**ABSTRACT**

This document describes the known exceptions to the functional specifications (advisories).

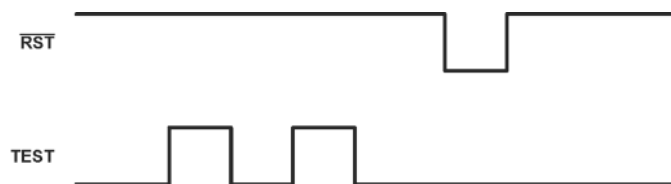
The methods used to exit the BSL per MSP430 Programming Via the Bootstrap Loader ([SLAU319](#)) are invalid.

**Workaround**

To exit the BSL one of the following methods must be used.

**SYS10****SYS Module****Category**

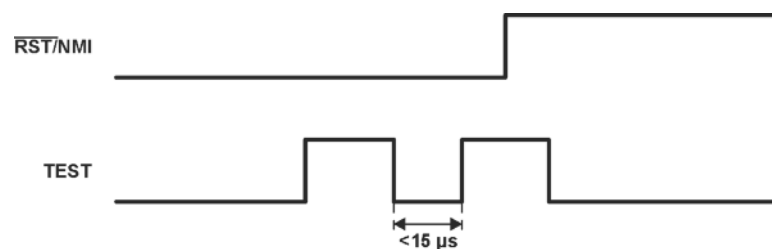
The BSL entry sequence requires that the low phase of the TEST/SBWTCK pin does not exceed 15 $\mu$ s. This timing requirement is faster than most PC serial ports can provide, as shown in the following picture. If this requirement is not met, the entry sequence fails and the SYSBSLIND is not set.

**Workaround** An external hardware solution is recommended to provide the appropriate BSL entry sequence. See [http://processors.wiki.ti.com/index.php/BSL\\_\(MSP430\)](http://processors.wiki.ti.com/index.php/BSL_(MSP430)) for recommendations on available BSL hardware.
